STAFF RECOMMENDATION

2502 Ashwood Avenue

Application: Violation--addition

Description of Project: Application is to revise a previously-approved permit for an addition to 2502 Ashwood Avenue after work was done that did not meet the preservation permit.

Figures 2 & 3 show the two-foot ridge raise and addition that was approved in July 2016.

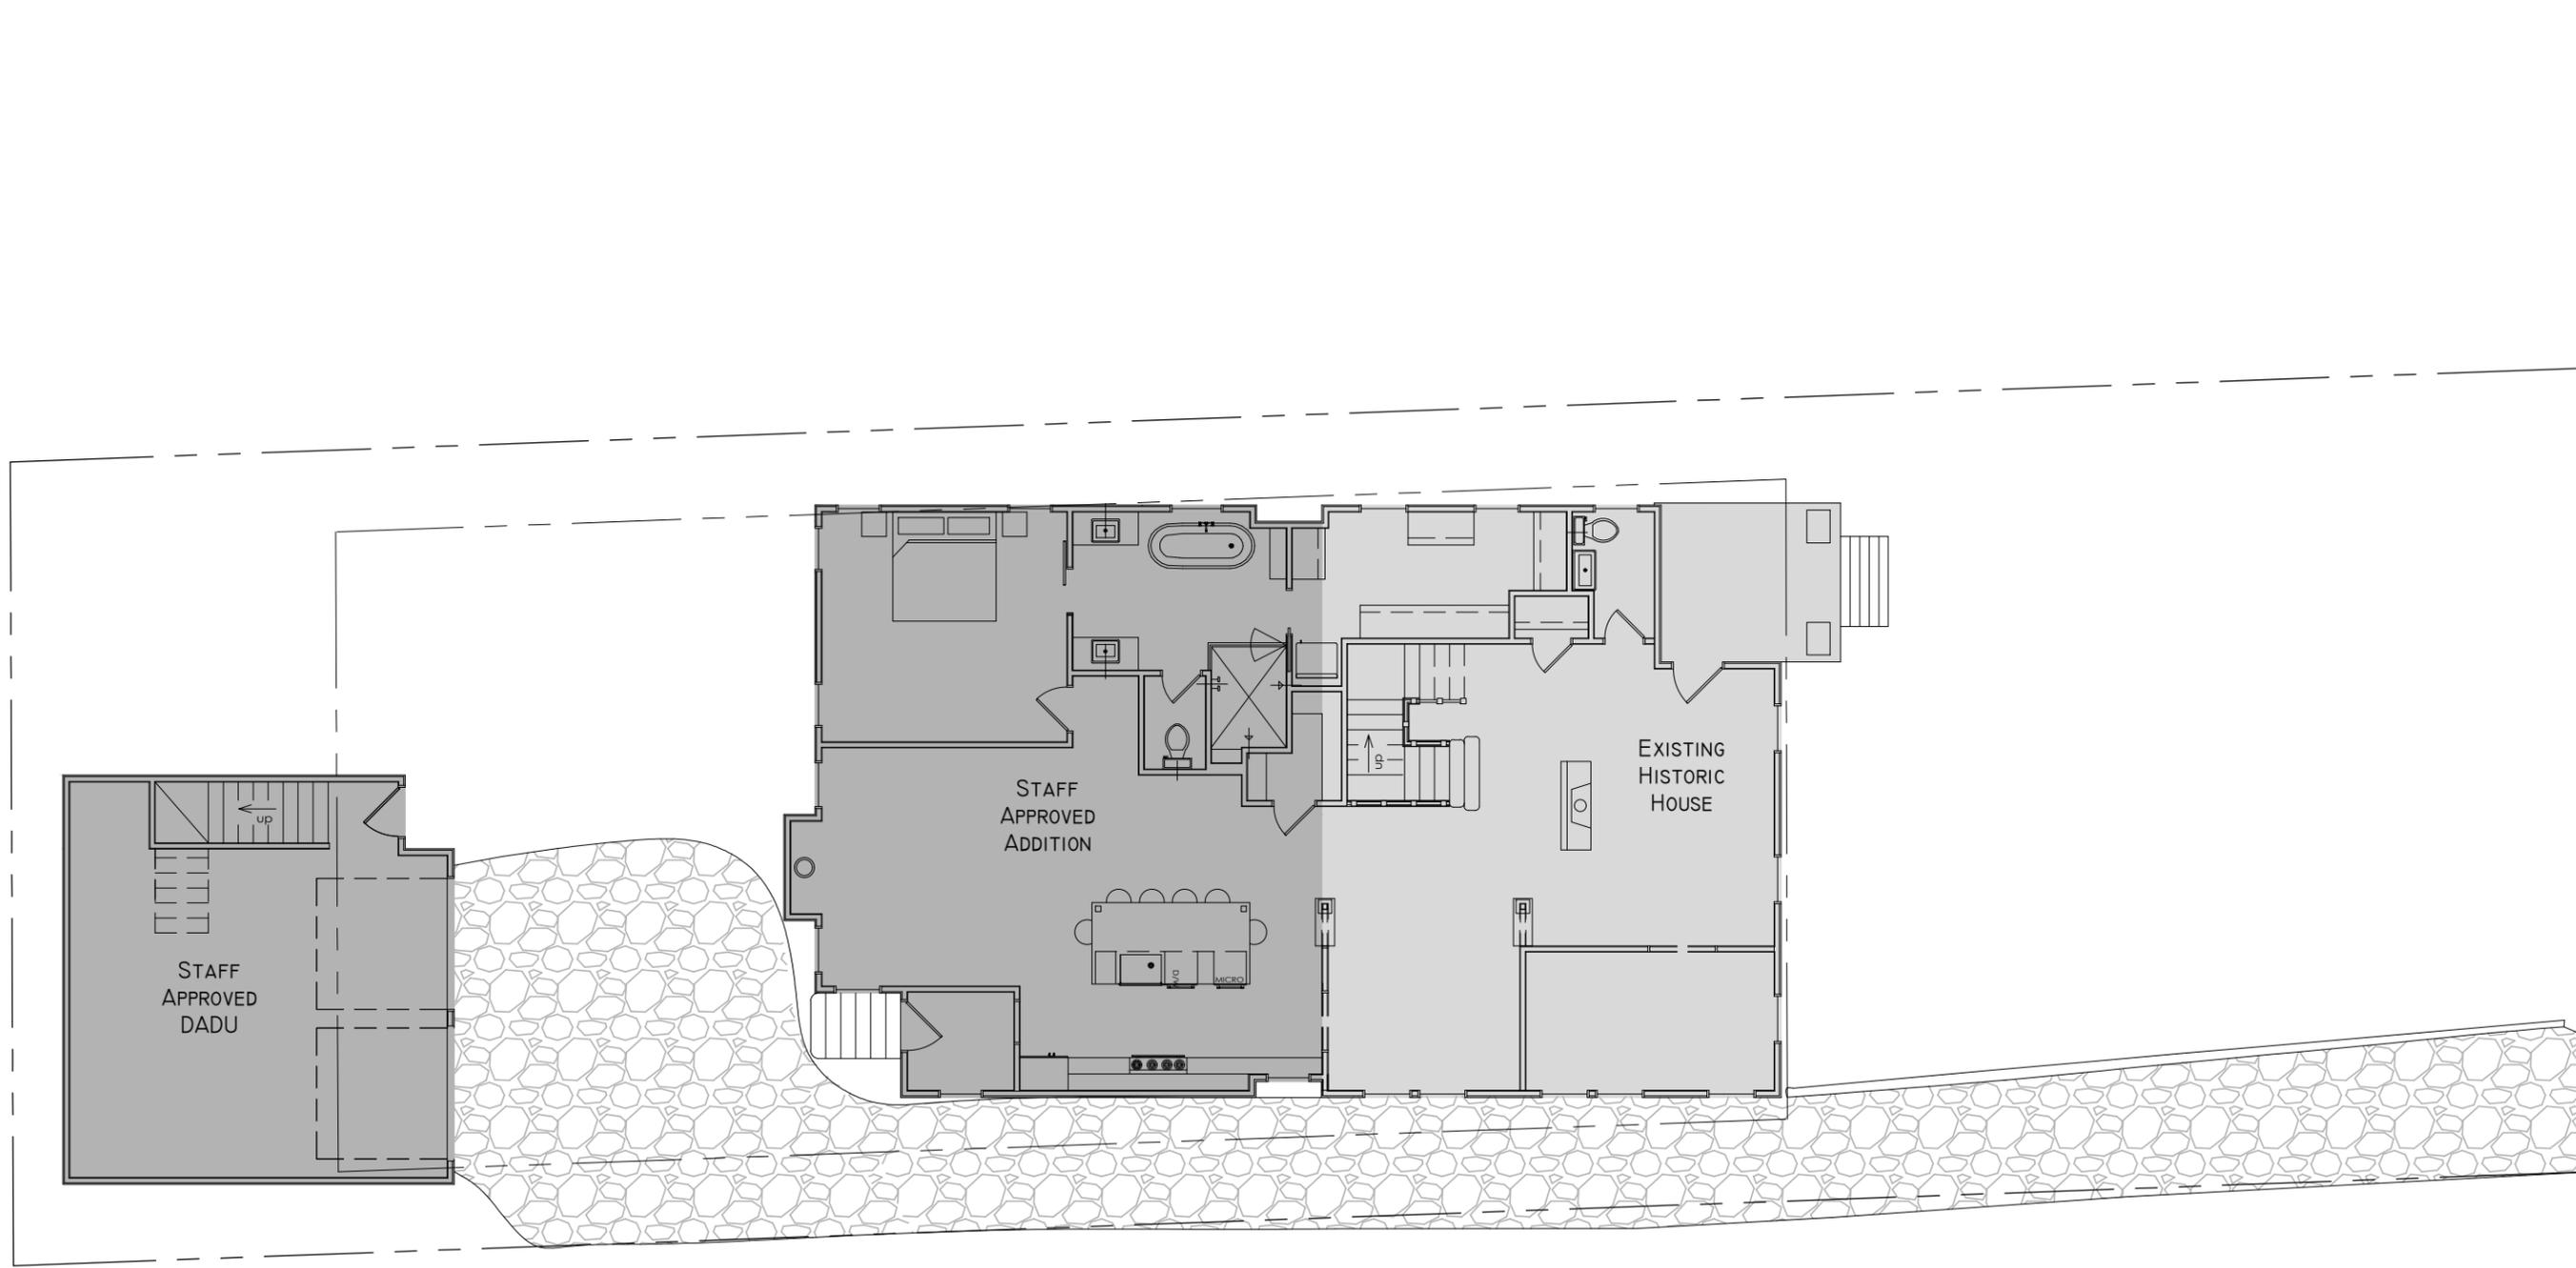
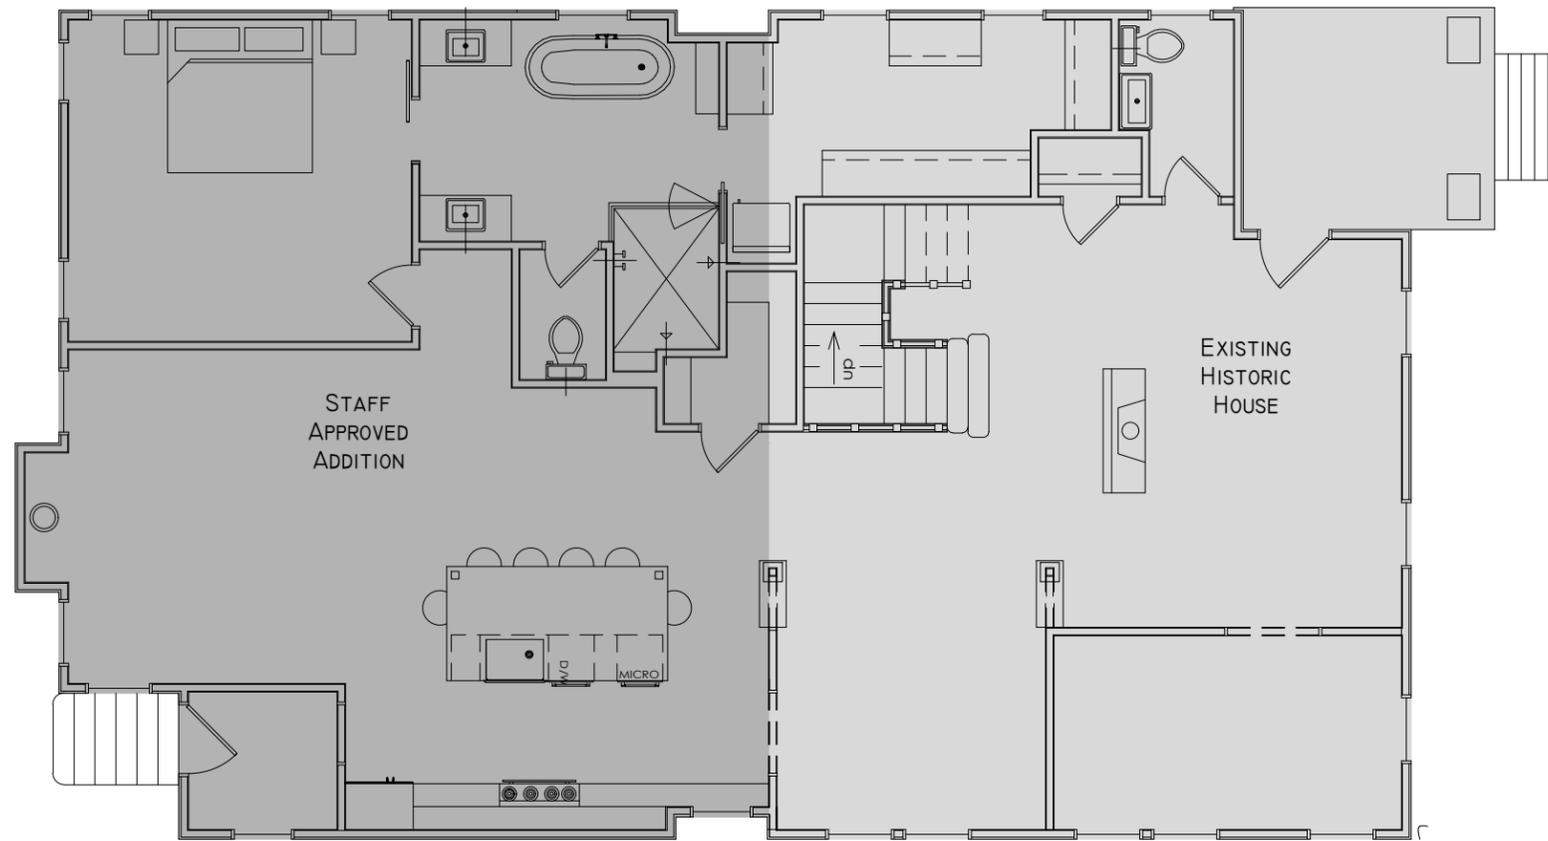
The previously-approved addition had a ridge height of two feet (2'), so the addition was two feet (2') taller than the historic house. The ridge height was constructed as four feet (4') tall, which is two feet (2') taller than what the design guidelines allow. The applicant has revised the design so that the ridge raise will only be two feet (2') tall, thereby meeting the design guidelines. At a point thirty-eight feet (38') back from the front of the house, the addition peaks at an additional two feet (2'), so that the addition will be a total of four feet (4') taller than the historic house.

The design guidelines state that “*additions to single story structures may rise as high as 4' above the shadow line of the existing building at a distance of 40' from the front edge of the existing building.*” Staff recommends that the taller portion of the addition be pushed back two feet (2') so that it does not occur until forty feet (40') from the front wall of the house, as per the design guidelines. With this condition, staff finds that the revisions to the addition meet Sections II.B.1.a., II.B.1.b., and II.B.2. of the design guidelines

Figures 4 & 5 show the four foot (4') ridge raise.

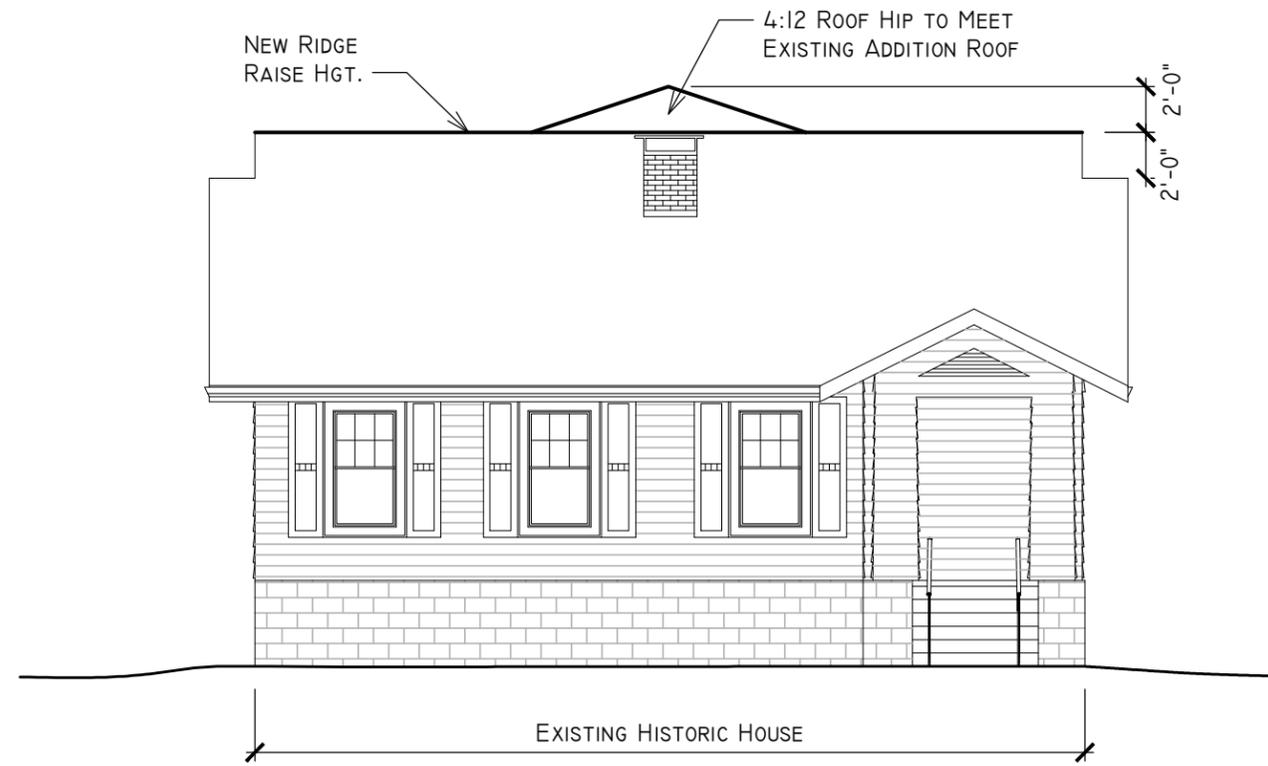
Roof form: As discussed under height and scale, the applicant was approved for a two foot (2') ridge raise, but constructed the ridge raise at four feet (4') tall. The applicant will alter the work so that the ridge raise is two feet (2') tall. The ridge raise does inset two feet (2') from the side walls, per the design guidelines. The addition does include wall dormers, which were approved under the administrative permit. Staff determined that the wall dormers were appropriate because they are inset two feet from the back wall of the historic house, reducing their size and visibility. The wall dormers are gabled with a 4/12 pitch. With the condition that the ridge raise be no taller than two feet (2'), staff finds that the revised addition meets Sections II.B.1.e. and II.B.2. of the design guidelines.

1. The peak of the taller portion of the addition be located forty feet (40') back from the front of the house;
2. Staff approve the roof color, all windows and doors, and the materials of the rear stair and railing; and
3. The HVAC be located behind the house or on either side, beyond the mid-point of the house; and

NORTH ELEVATION

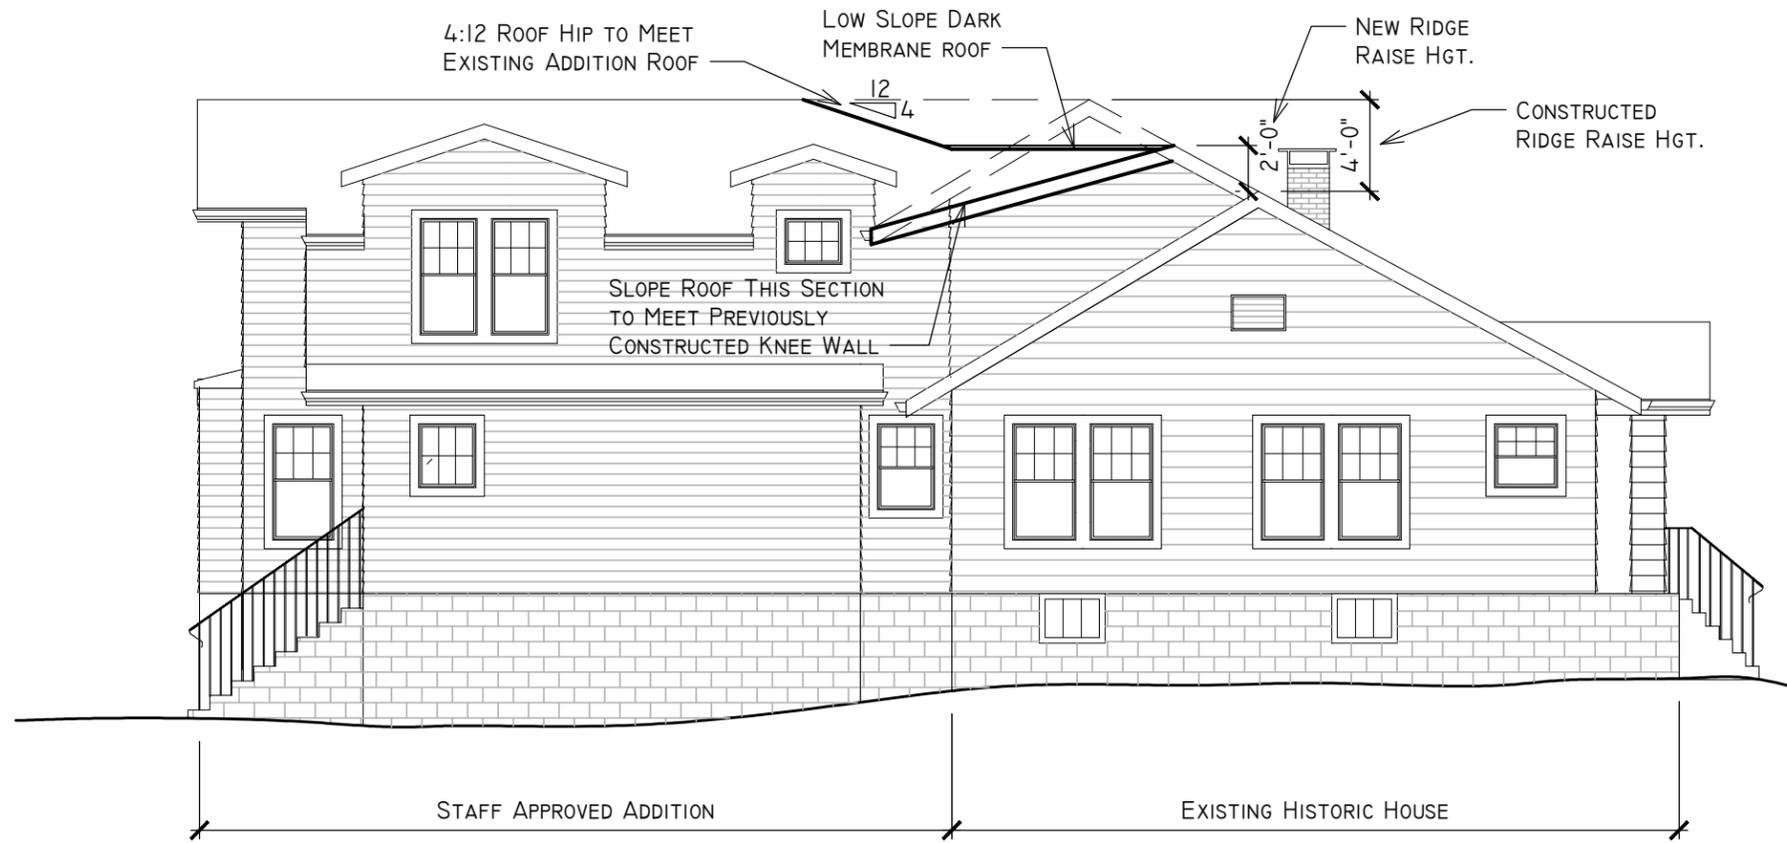
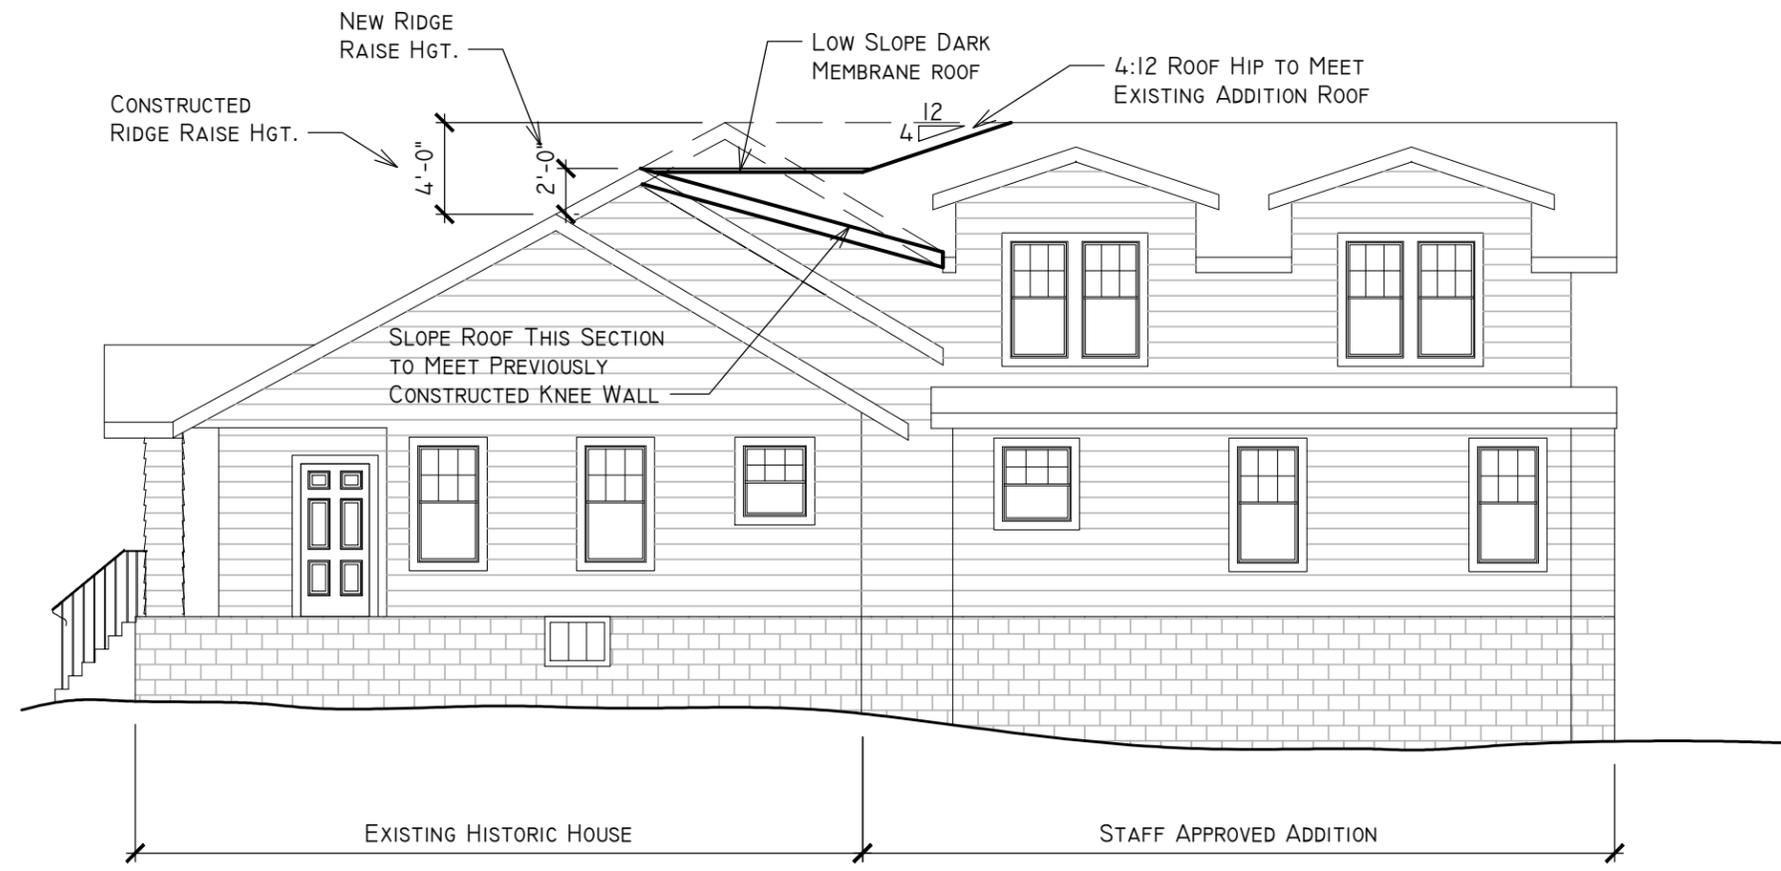
NEW RIDGE RAISE HGT.

CONSTRUCTED RIDGE RAISE HGT.

SLOPE ROOF THIS SECTION TO MEET PREVIOUSLY CONSTRUCTED KNEE WALL
